**Addendum No. 1**

Re: 1432-1438 Rosemont oh5-12b  
261 Hoch Street oh5-18d

Prepared by:  
The Oregon Group Architects

Project Name: DMHA Rosemont Hoch Electrical Upgrades and A/C Replacement

sheet  
**E3**  
 1432 rosemont blvd.

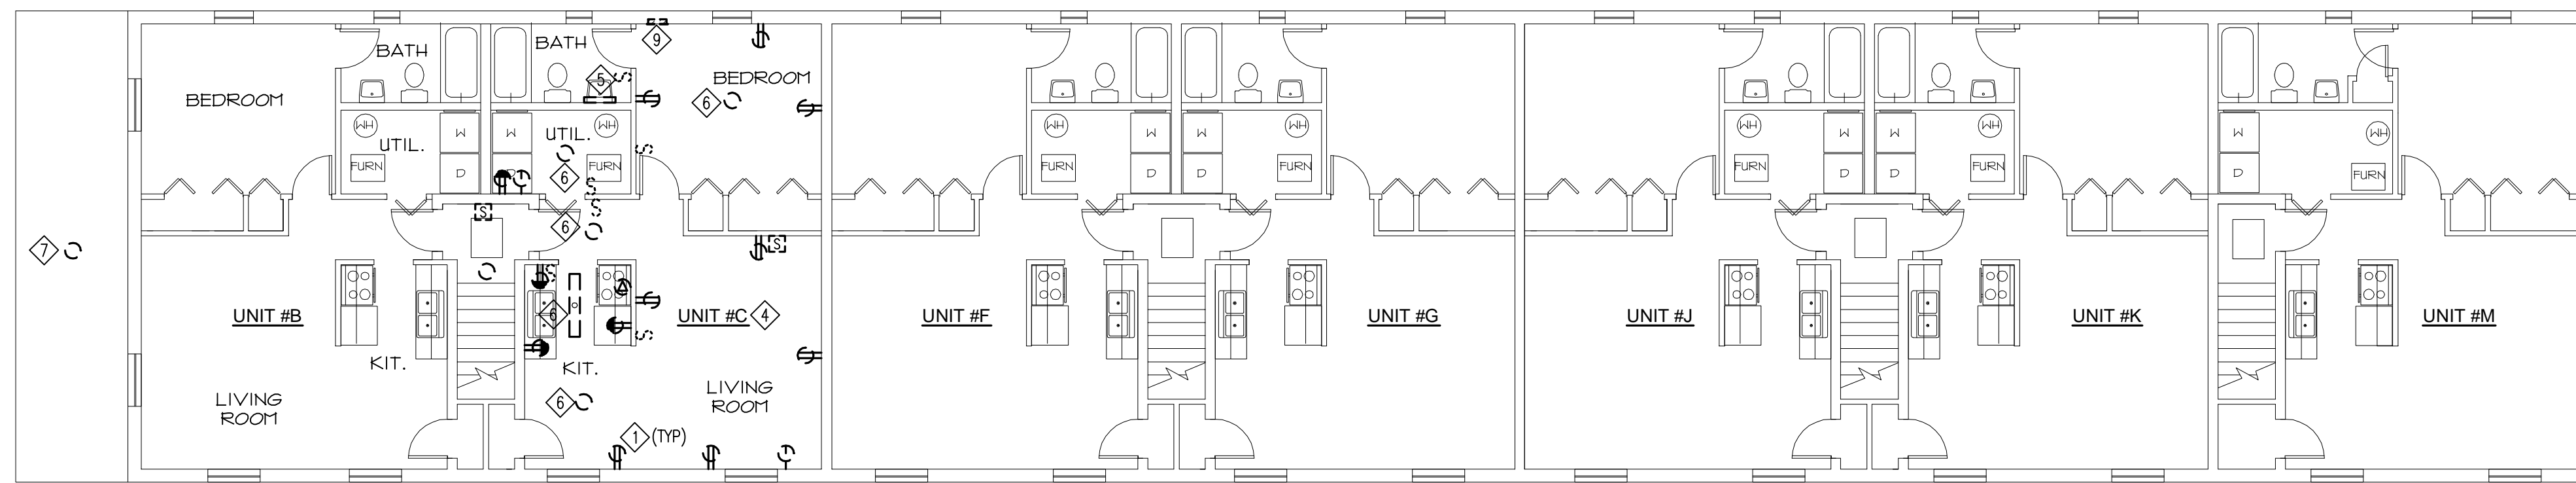
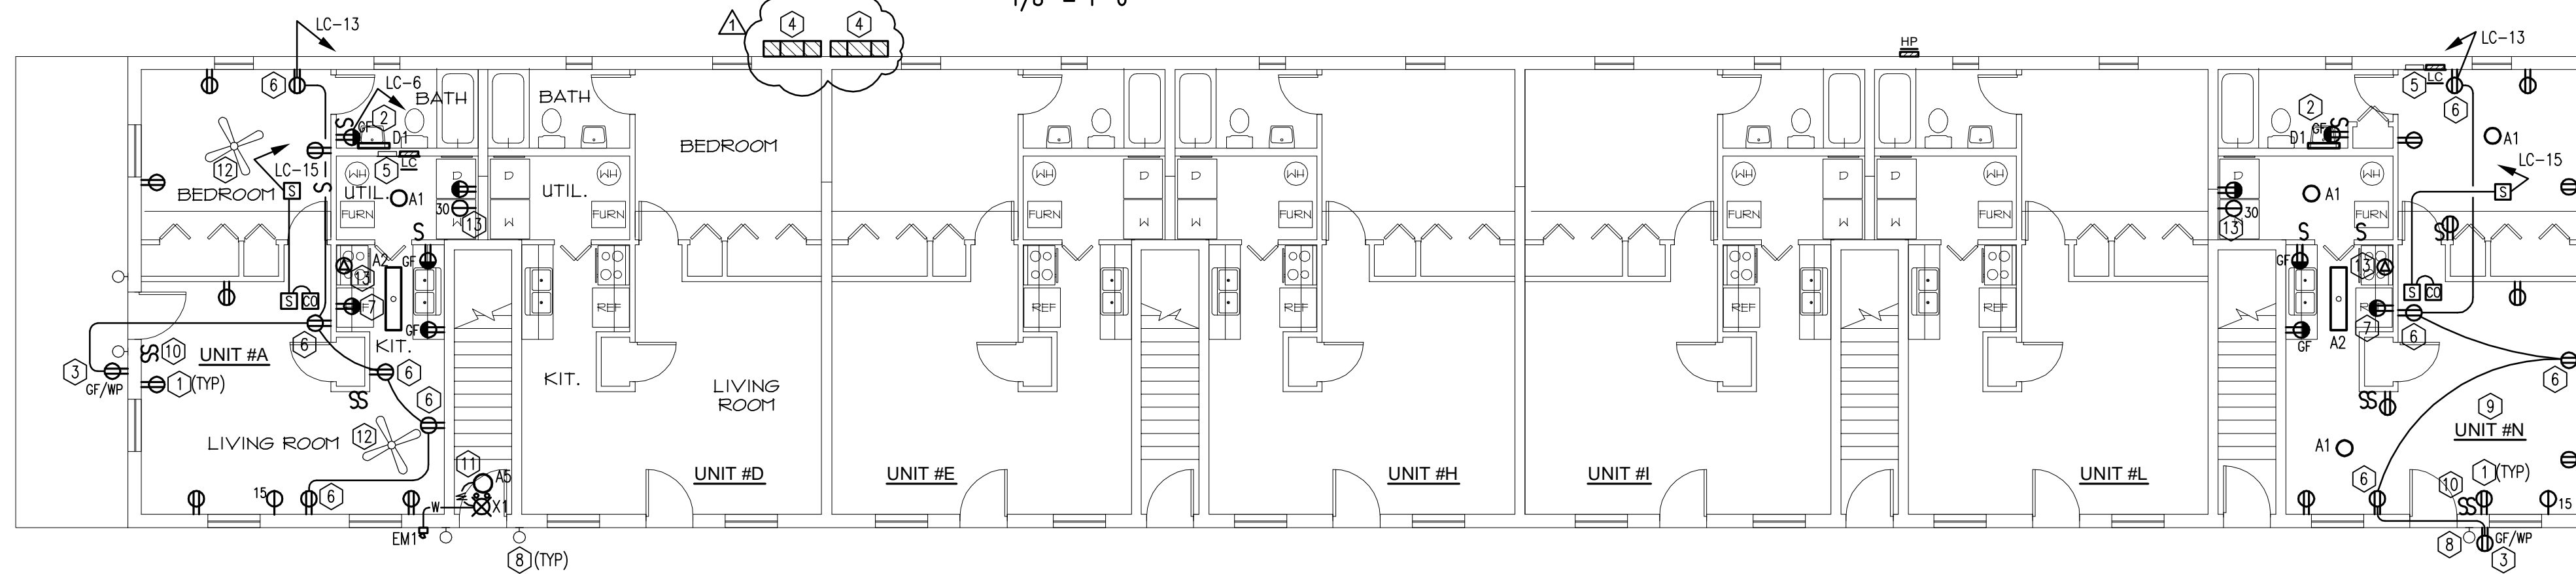
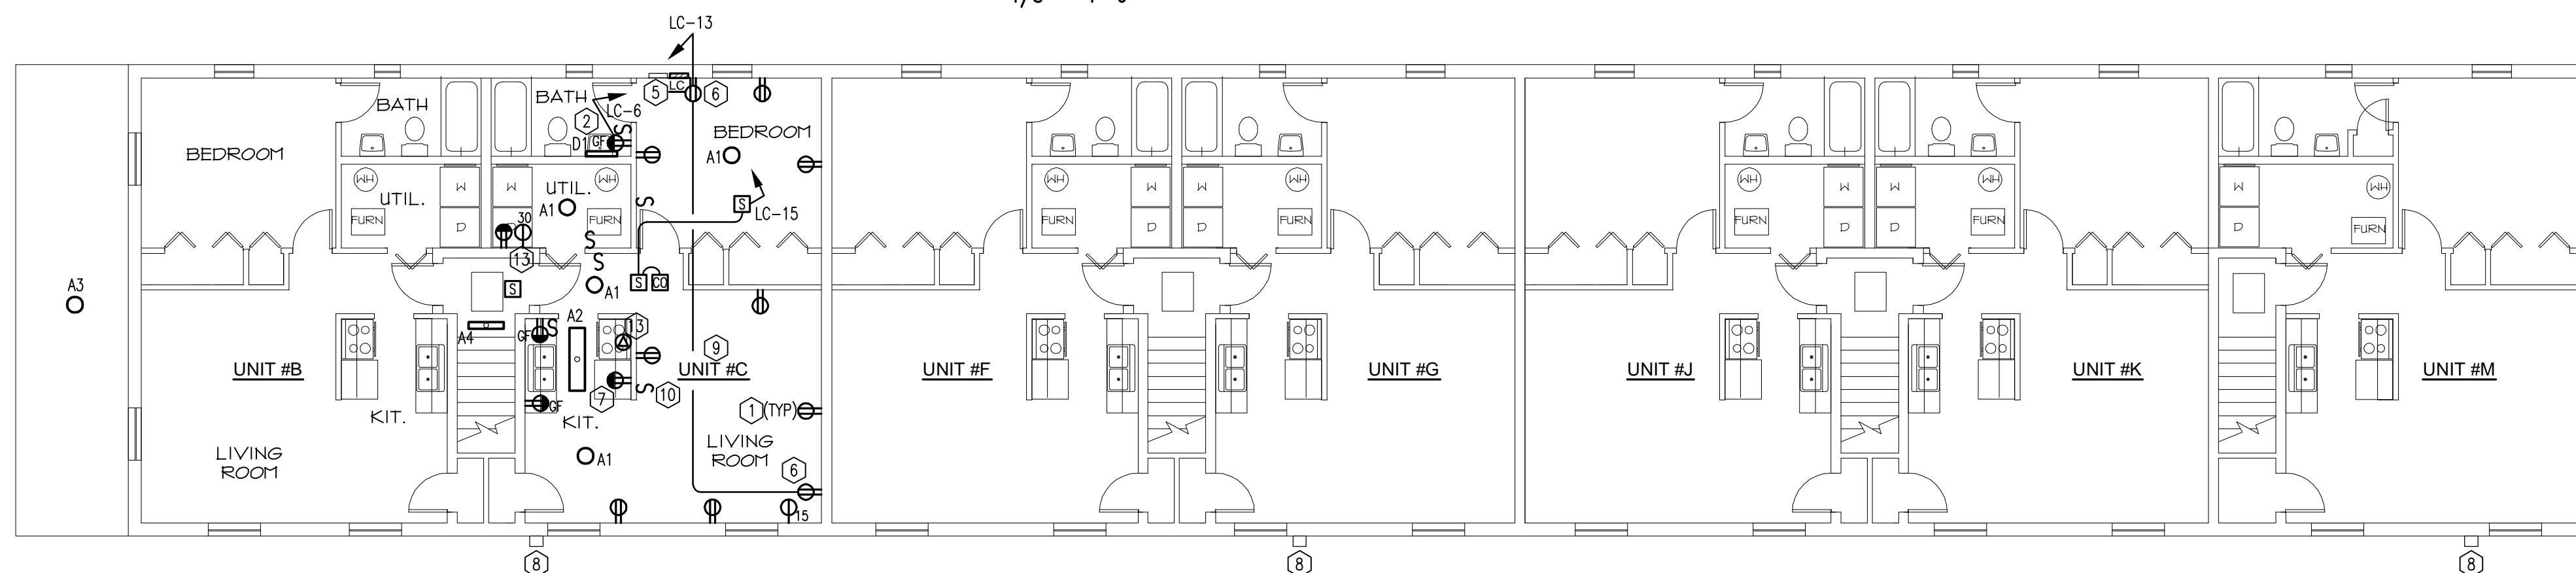
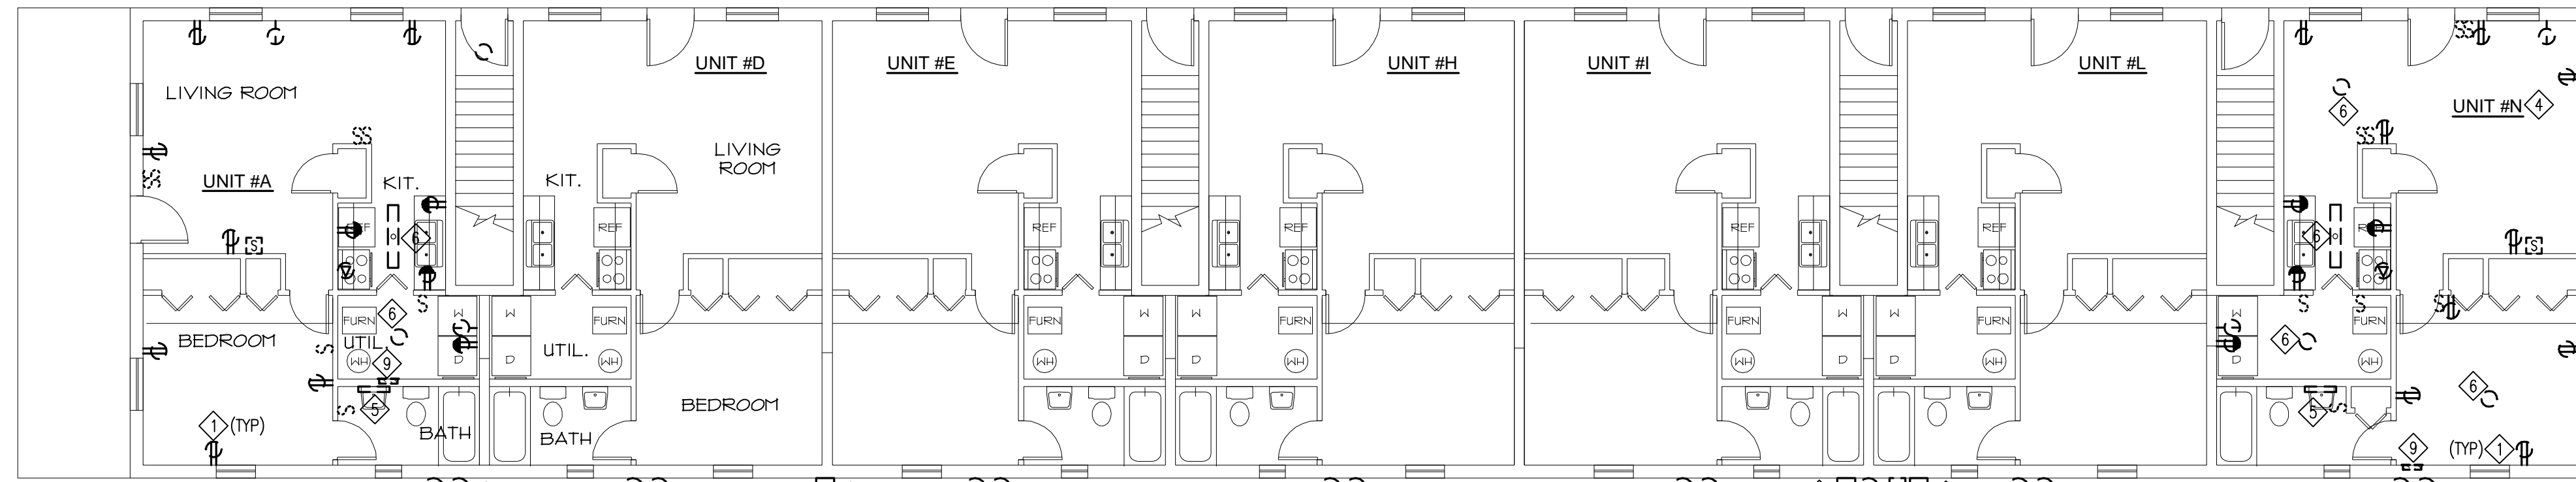
- Item No. 1: Delete Drawing Sheets E1, E3, E4 in their entirety.
- Substitute: Attached revised Drawing Sheets E1, E2, E4 in their entirety. Aerial service conductors to 1432 and 1438 Rosemont shall each extend to one location on buildings. Two meter centers for each Rosemont building are to be located adjacent to each other as shown on plans. Refer to clouded changes on revised sheets. Contractor shall coordinate with DP&L prior to any rough-in, for service drop location and shall provide necessary support structure or weatherhead(s) as required. Existing service conductor wall support brackets shall be removed, and brick surface repaired.
- Item No. 2: Add attached Pre-Bid Attendance Sheet and Meeting Minutes.

3. PROVIDE EXTERIOR RECEPTACLE PER NEC 210.52(E).
4. PROVIDE NEW METER CENTERS WITH 400A MAIN DISCONNECTS, EACH WITH EIGHT METER SOCKETS WITH 100A BREAKERS. PROVIDE WEATHERHEAD/SUPPORT FOR SERVICE CONDUCTORS AND TAP CONDUCTORS TO SERVE MAIN 400A DISCONNECTS. PROVIDE 100A FEEDERS TO LOAD CENTERS. PROVIDE SURFACE CONDUIT ON BUILDING EXTERIOR TO ROUTE SERVICE CONDUCTORS FROM ARIAL DROP. DOWN TO METER CENTERS. PROVIDE VERTICAL WIREWAY(S) FROM METER CENTER FOR LOADCENTER FEEDER ROUTING, AND PROVIDE HORIZONTAL WIREWAY OR FLANGE GUARD SIMILAR TO WIRE TRAK - ALPHA TRAK WIRE MANAGEMENT SYSTEM SUCH THAT ALL SURFACE MOUNTED SER CABLE IS CONCEALED. REWORK EXISTING DOWNSPOUTS AS NECESSARY TO ALLOW CROSSING OF WIREWAY OR FLANGE GUARD. COORDINATE INSTALLATION METHODS WITH DMHA, ARCHITECT/ENGINEER PRIOR TO WORK FOR NEAT, ORDERLY APPEARANCE. WIREWAY AND FLANGE GUARD COLOR SHALL BE SELECTED TO BLEND WITH BRICK SURFACE.
